Property Alliance Group / Starwood Capital Group Renaissance Site

Residential Building Section 73 Application (141175/JO/2024)

Issue No. 03 23.10.25

5.2 Level 20
S73 Proposal

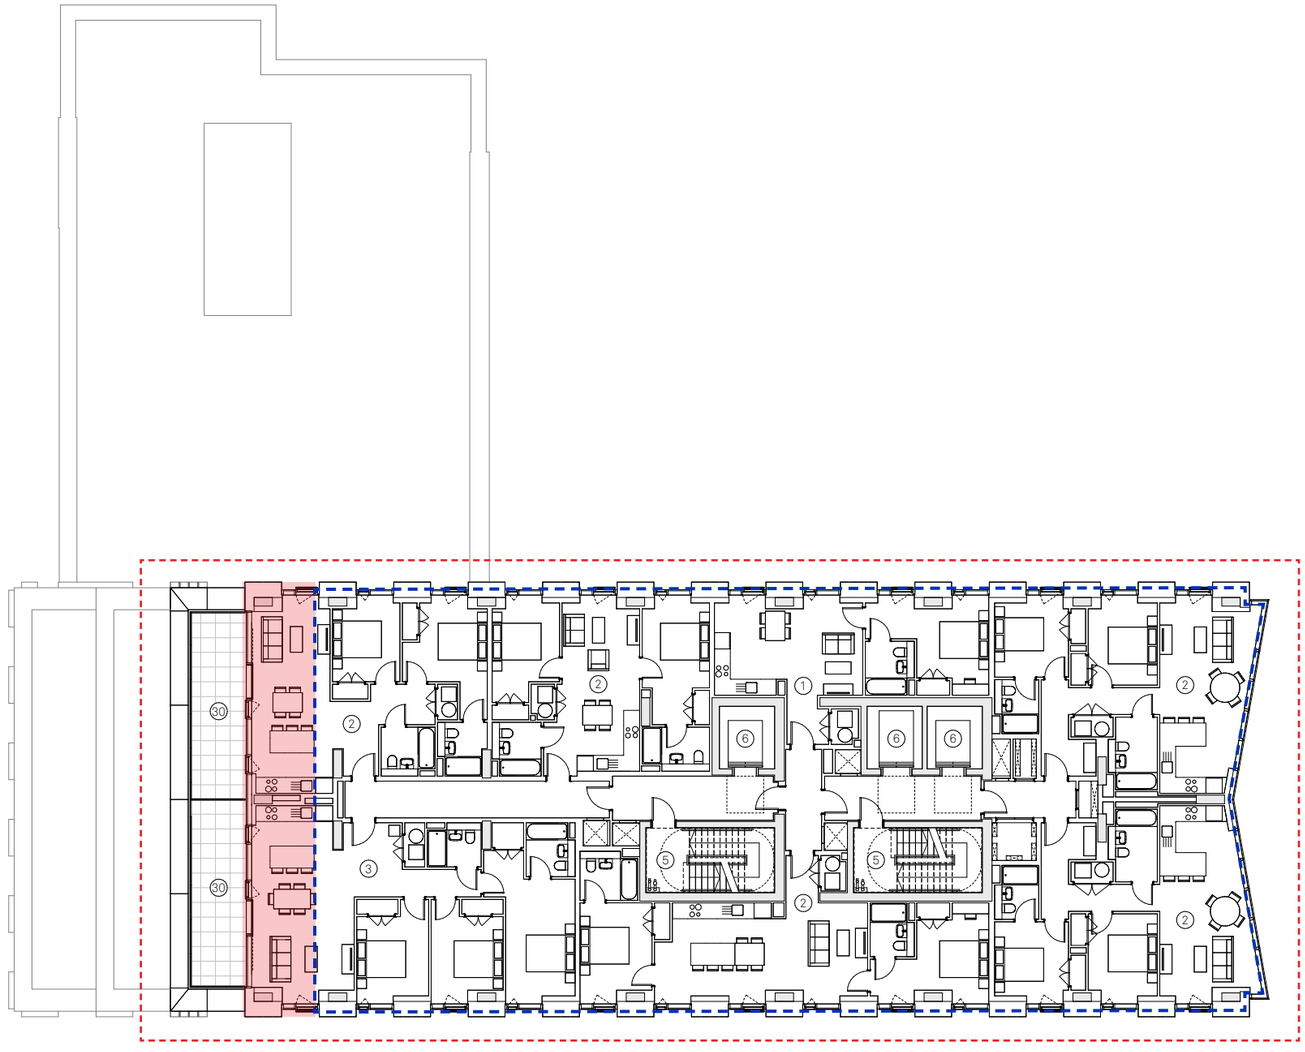
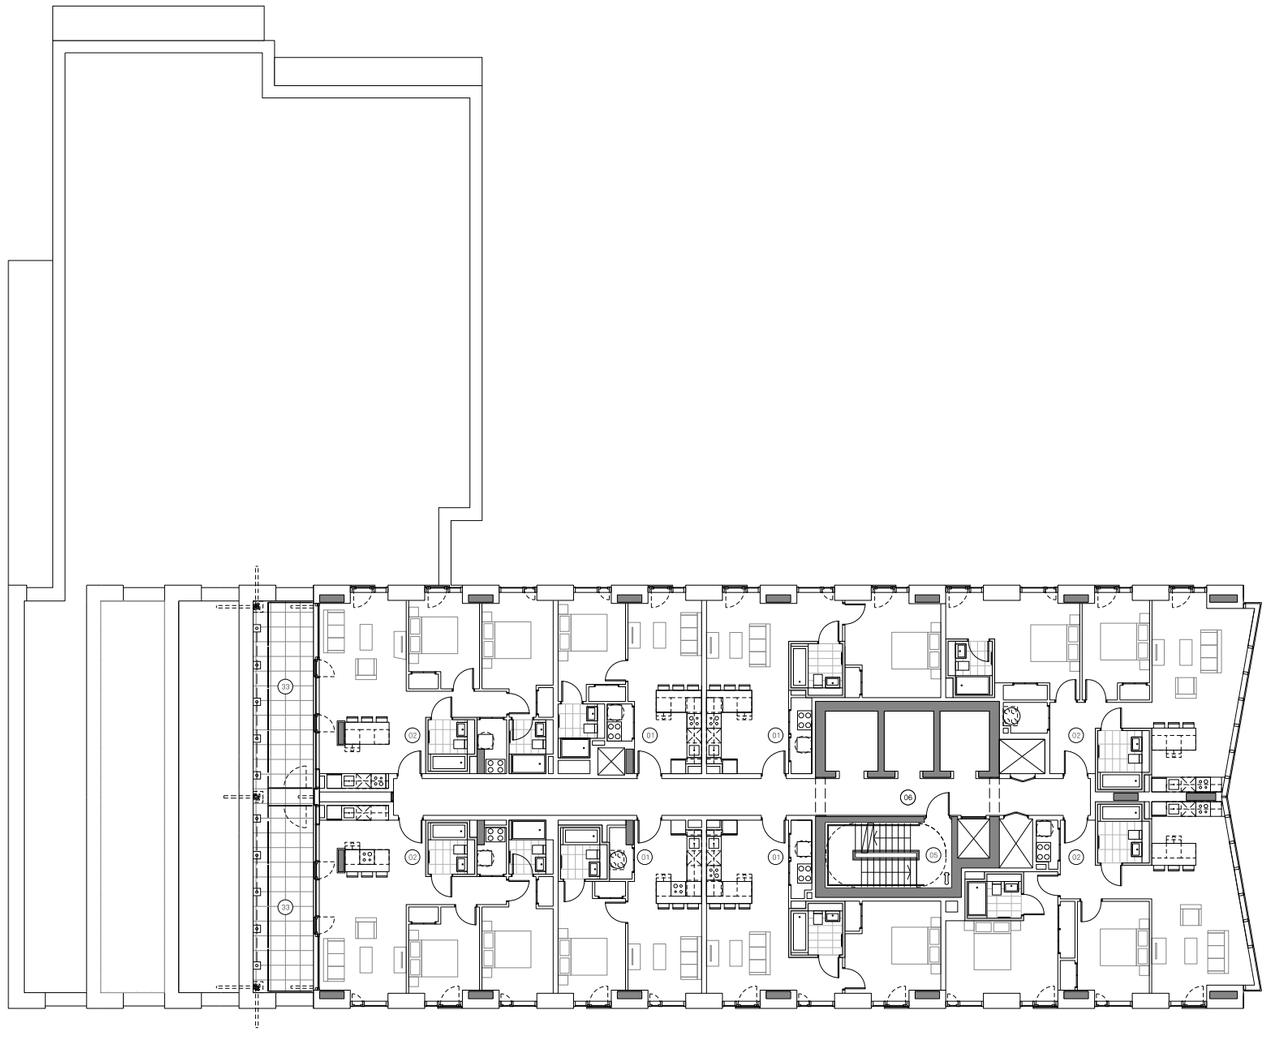
Sept 2024 Amendments:
(141175/JO/2024)
- Fire-fighting lobby added to all floors with an +1 additional stair and associated fire fighting lobbies.
- Internal floor plate extended into previous / consented external terrace area. Therefore the 20th floor massing increased where identified.
- Scale, massing and elevation amendments proposed where the floorplate is extended.

5.2 Level 21
S73 Proposal

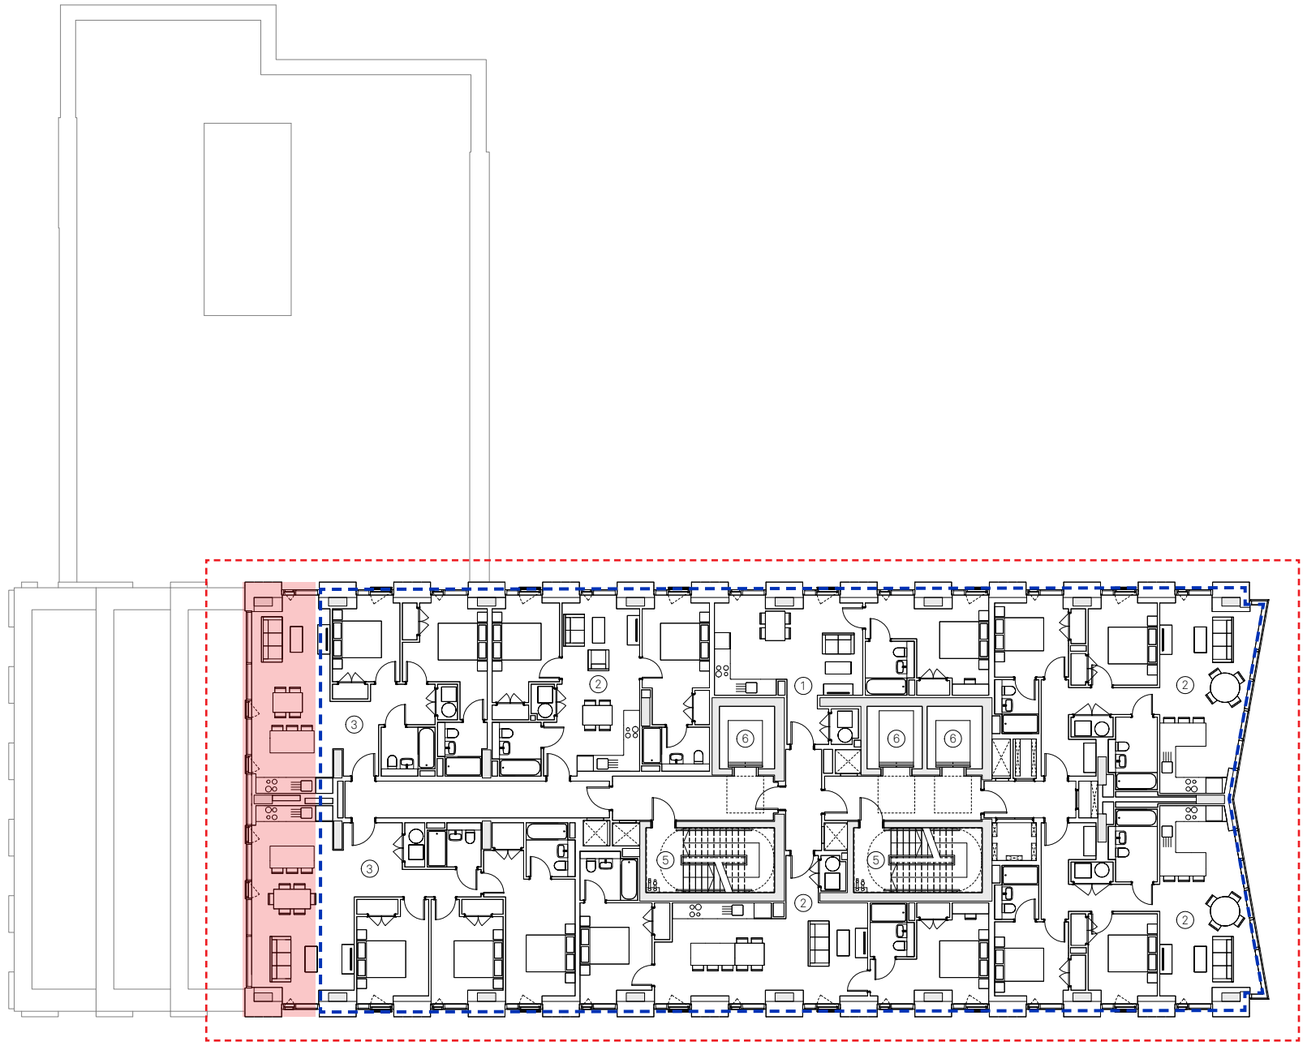
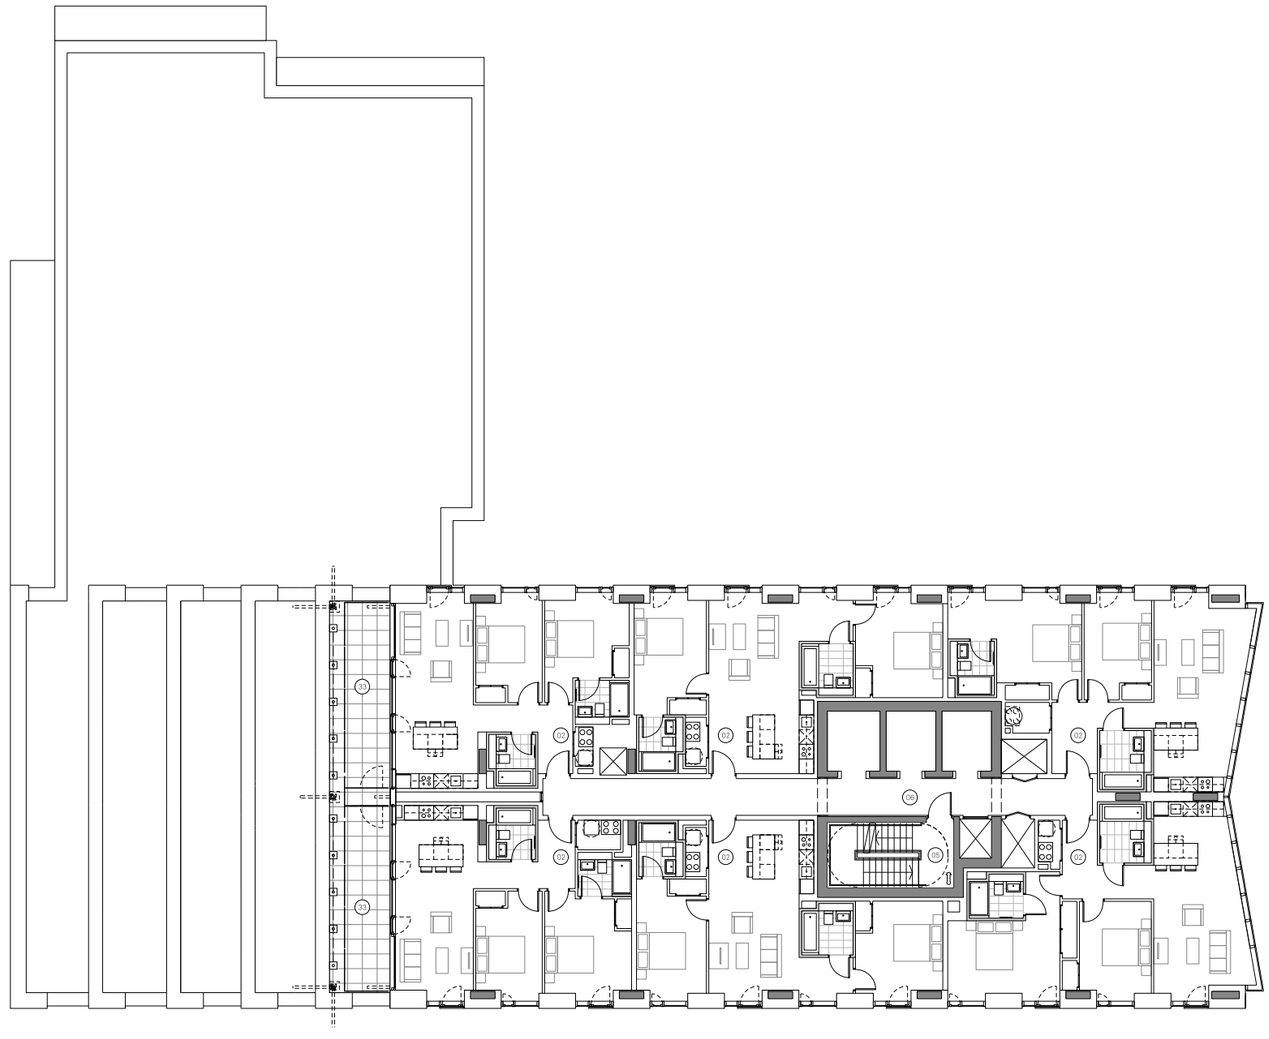
- Fire-fighting lobby added to all floors with an +1 additional stair and associated fire fighting lobbies.
- Internal floor plate extended into previous / consented external terrace area. Therefore the 21st floor massing increased where identified.
- Scale, massing and elevation amendments proposed where the floorplate is extended.

5.2 Level 22-23
S73 Proposal

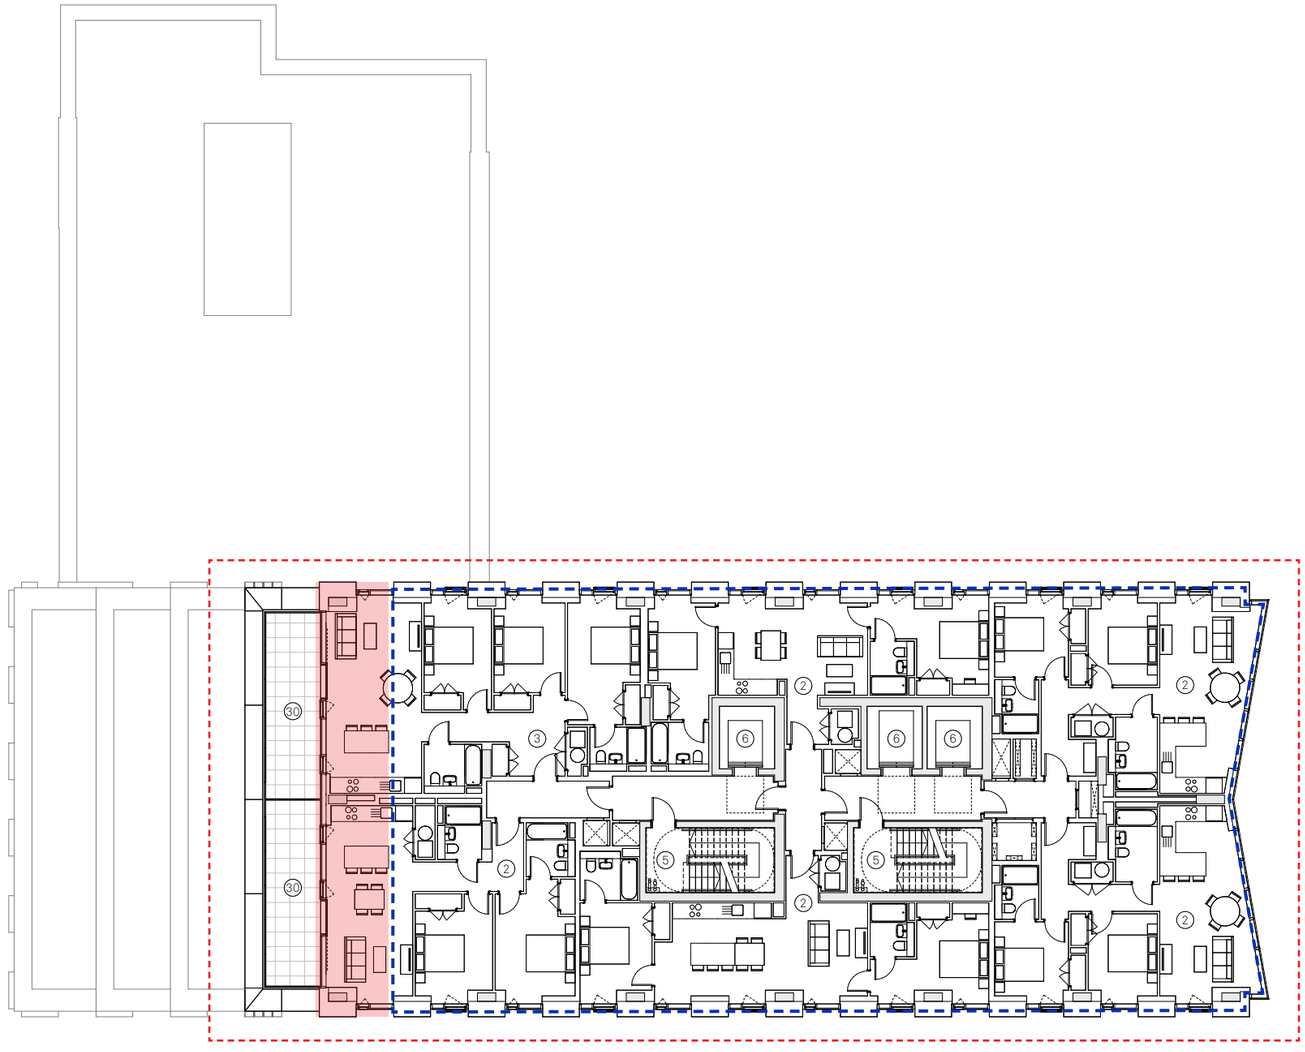
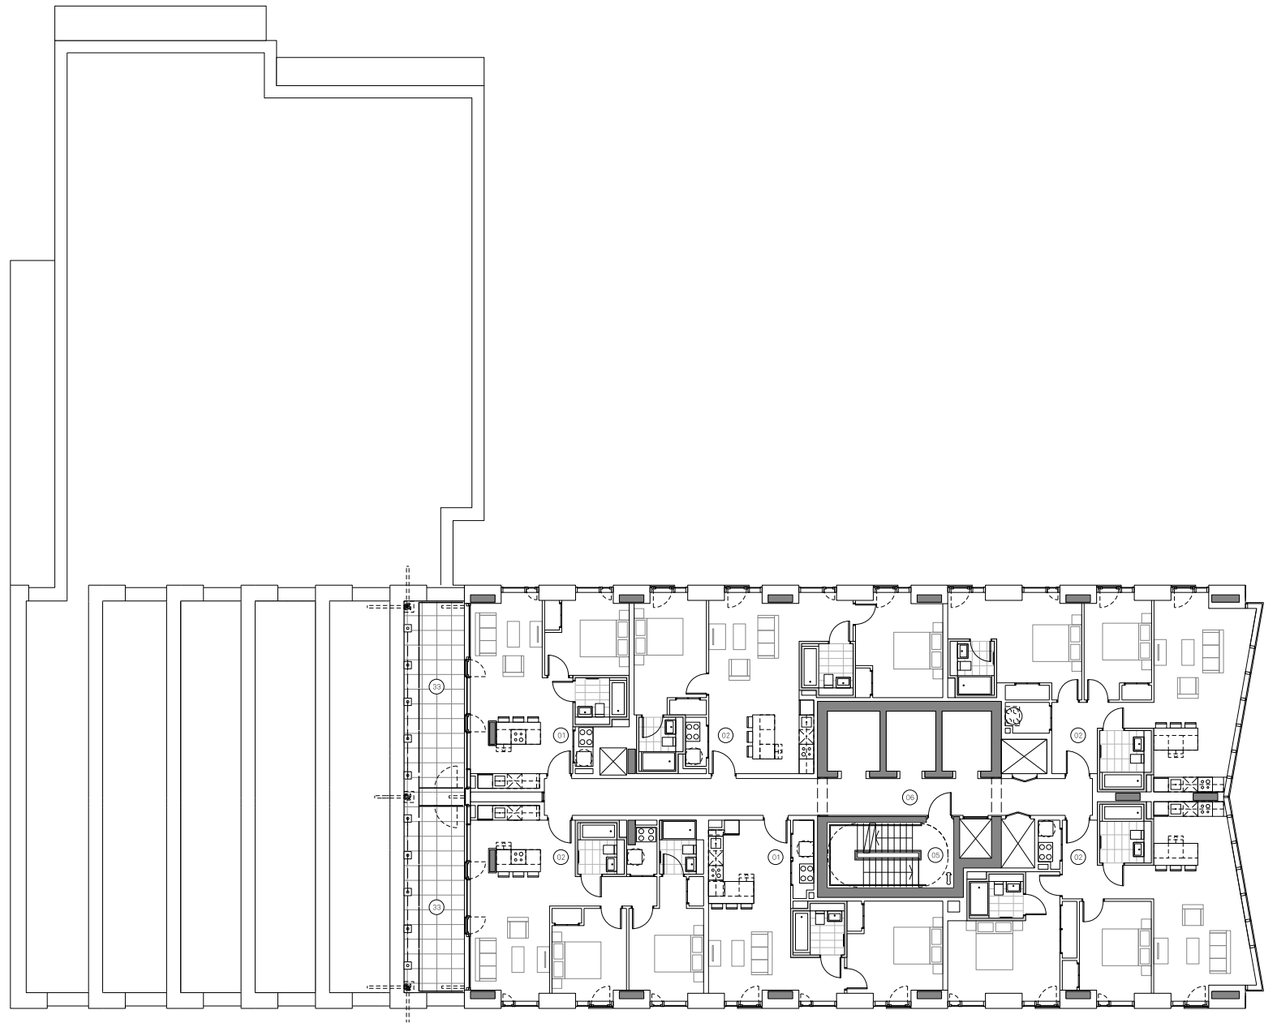
Sept 2024 Amendments:
(141175/JO/2024)
- Fire-fighting lobby added to all floors with an +1 additional stair and associated fire fighting lobbies.
- Internal floor plate extended into previous / consented external terrace area. Therefore the 22nd & 23rd floor massing increased where identified.
- Scale, massing and elevation amendments proposed where the floorplate is extended.

5.2 Level 24-25
S73 Proposal

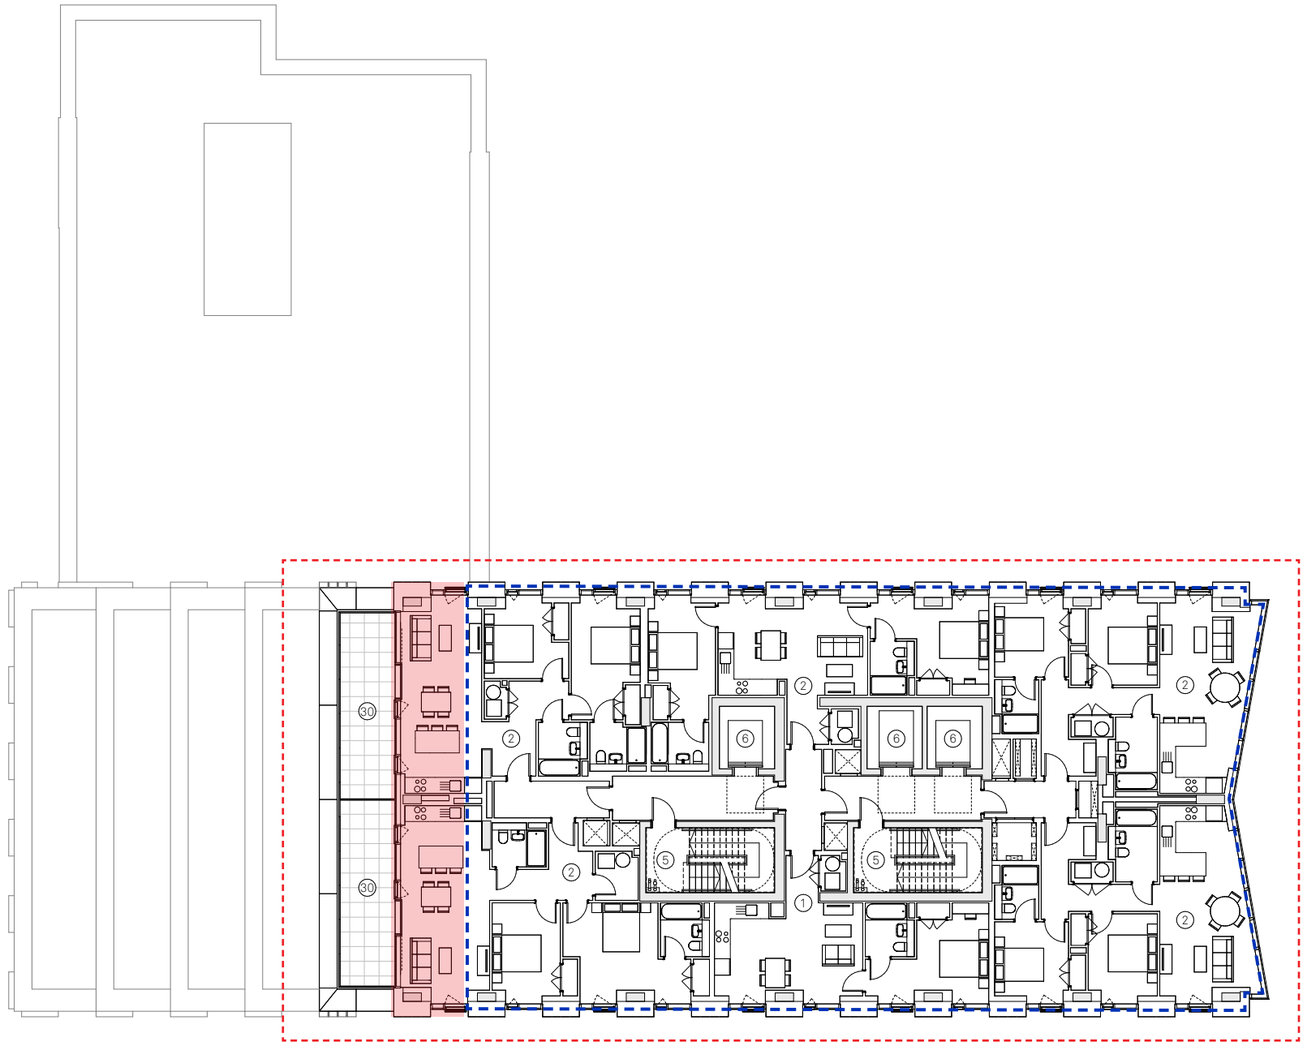
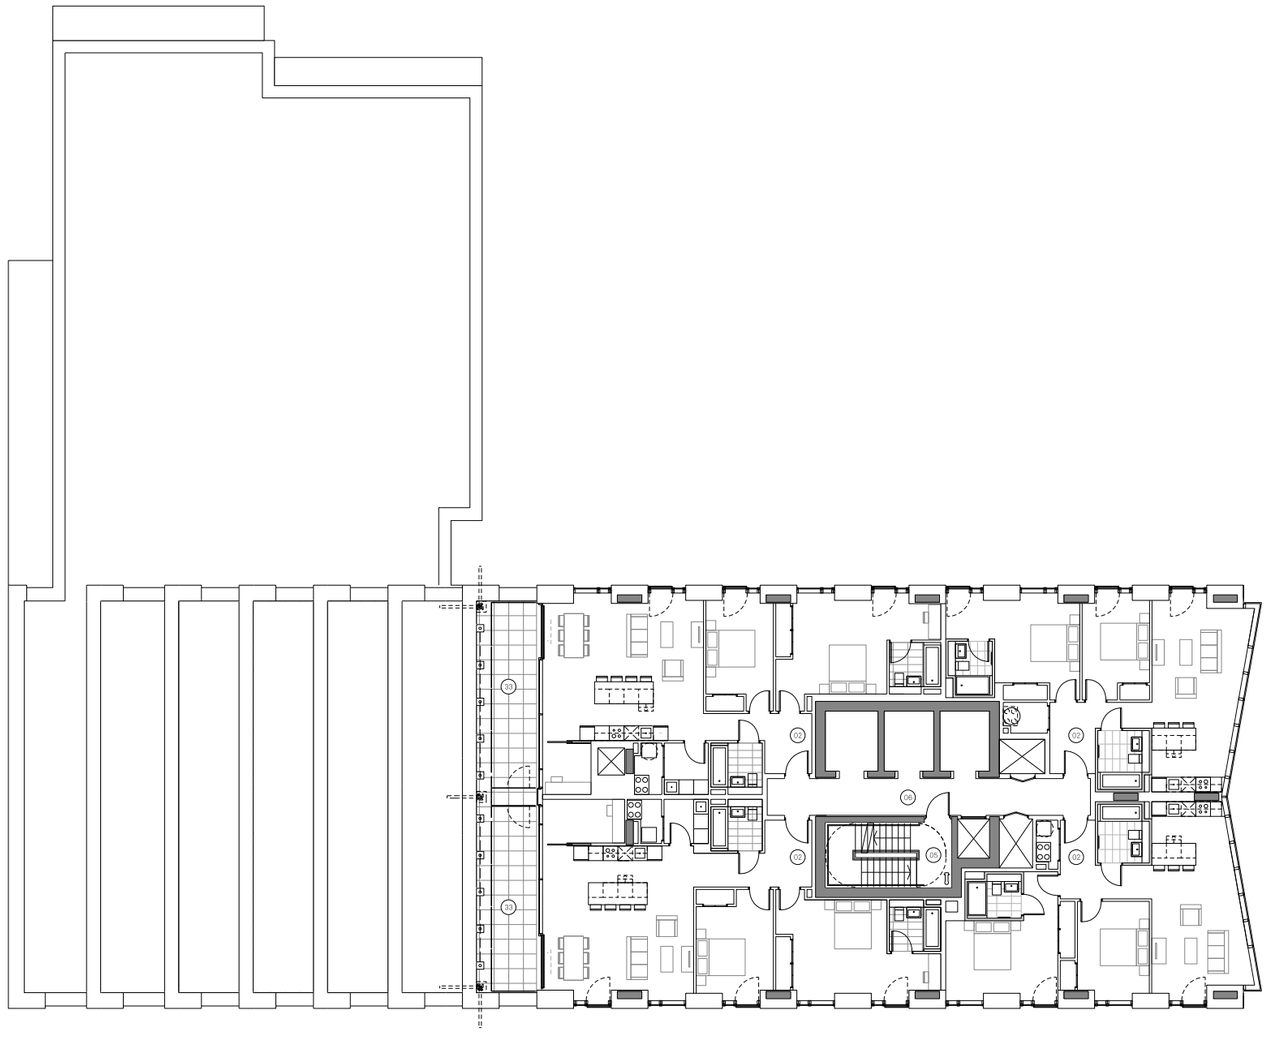
Sept 2024 Amendments:
(141175/JO/2024)
- Fire-fighting lobby added to all floors with an +1 additional stair and associated fire fighting lobbies.
- Internal floor plate extended into previous / consented external terrace area. Therefore the 24th & 25th floor massing increased where identified.
- Scale, massing and elevation amendments proposed where the floorplate is extended.
